SB-10044143-3305

Power Steering Hose Leaks at Clamps

Models Affected: 2009 to 2013 Model Year Visions with GM Propane Engines

S I 2 T X
S E R V I C E B U L L E T I N

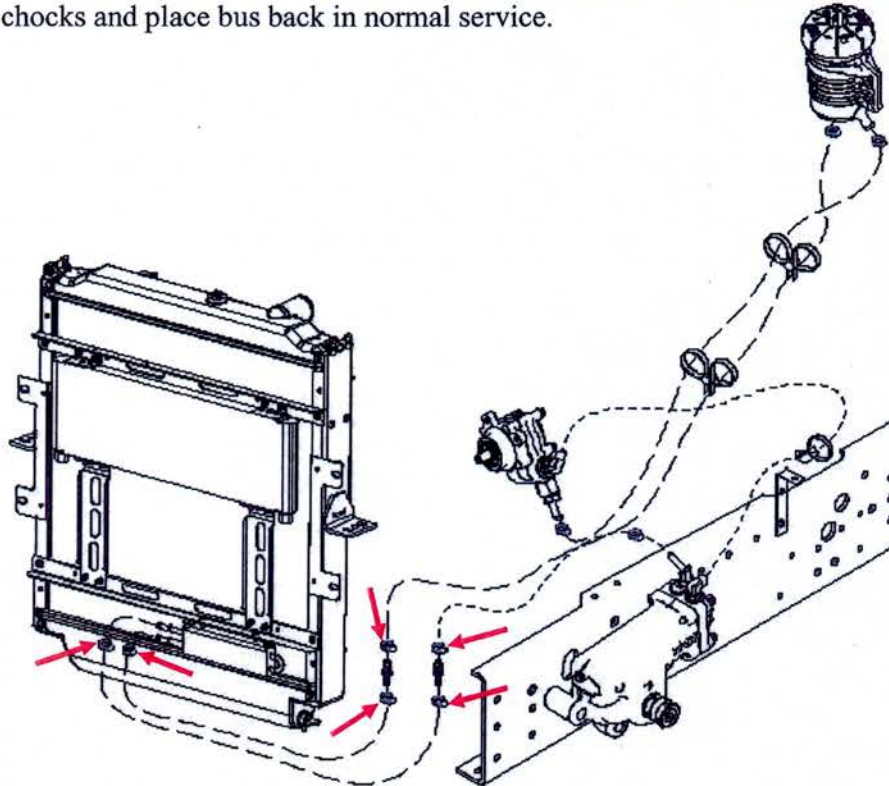
Power steering hose may leak at clamps due to clamps not being torqued to the proper specification.

Loosen power steering hose clamps re-tighten and torque to proper specification.

1. Park bus on a level surface, apply parking brake, remove ignition key, and chock wheels.
2. Locate four power steering hose clamps behind frame rail, left side of radiator and two hose clamps on power steering cooler.
3. Loosen clamps then re-tighten to 15 in-lbs. If clamps cannot be torque properly, replace with clamp BB# 02027571.
4. Start engine, steer bus on full right and one full left turn. Check all connections for leaks.
5. Remove chocks and place bus back in normal service.
